ACCESS COMPLIANCE ASSESSMENT REPORT

Building Code of Australia 2022 Amendment 2

PROJECT:	64–66 Lavender Street and 3–7 Middlemiss Street, Lavender Bay
REF. No.:	NEW250951 (Rev 2)
DATE:	21/04/2026
CLIENT:	Central Element
CONTACT:	Hugh Roberts
EMAIL:	hroberts@ centralelement.com.au
CONSULTANT:	Mauricio Vera
PHONE No:	0451 078 790
EMAIL	mvera@newcrown.com.au

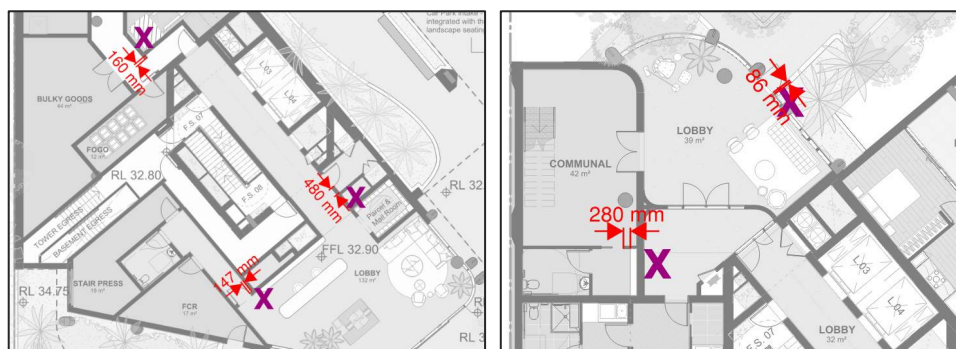
- Various insufficient door width:

- Doors to lift lobbies: At least one door leaf to achieve 850mm minimum.
- Doors to Communal Room (ground floor): At least one door leaf to achieve 850mm minimum.
- Doors to Waster Room (Building A): At least one door leaf to achieve 850mm minimum.
- Doors to Yoga Room: At least one door leaf to achieve 850mm minimum.
- Doors to Communal Room (Levels 4 and 5): At least one door leaf to achieve 850mm minimum.

Building A:

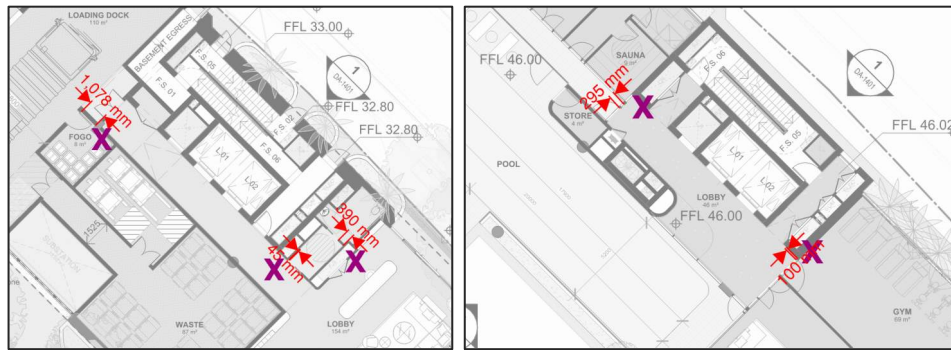
- Sliding doors to accessible WC (ground floor): Insufficient latch-side clearance.
- Door to FOGO Room: Insufficient length.
- Door to Gym: Insufficient latch-side clearance.
- Corridor door to swimming pool: Insufficient latch-side clearance.

3. Path of Travel – Ramps (BCA D4D4, D4D12 & AS1428.1)

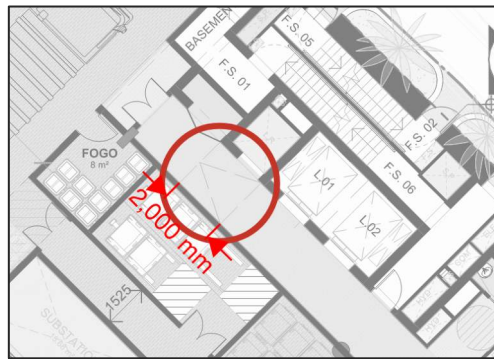
Excessive length of 2000mm in lieu of 1900mm maximum at the 1:10 step-ramp in Building A lift lobby on ground floor is identified, in non-compliance with this clause and AS1428.1. To be rectified.

4. Paths of Travel – Stairs (BCA D4D4 & AS1428.1)

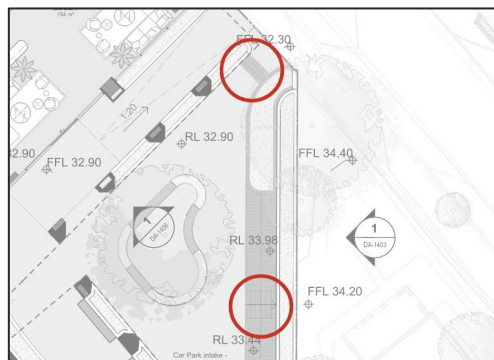
- Absence of handrails on each side to the stair connecting northern landscape, in non-compliance with this clause. To be rectified.
- To allow use of a central-dual handrail in lieu of handrails on both sides of the stair to serve the tiered-seating areas, and no top landings, in non-compliance with this clause. Performance Solution is available.

5. Internal doors and corridors

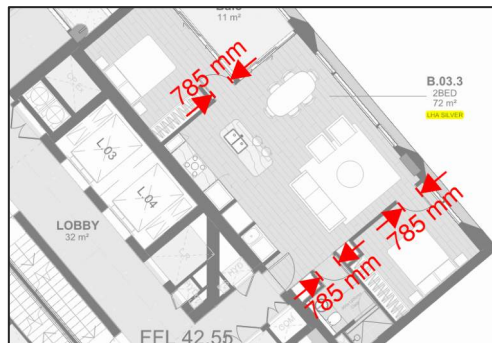
Various insufficient doorways clear widths of circa 785mm in lieu of 820mm minimum to at least one bedrooms, bathroom and Laundry, in non-compliance with this clause.

To be rectified/ clarified.

6. Toilets

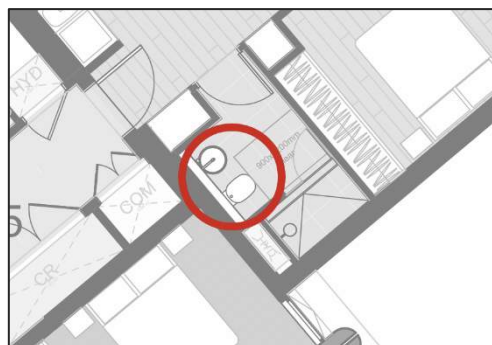
The toilet in the livable units have a clear (900x1200mm) circulation space in front of the pan, in compliance with this clause. However, these toilets are not located in the corner of the room to enable installation of grabrails and associated reinforcement in compliance with Item 6 of LHDG. In non-compliance with this clause.

To be rectified/ clarified.
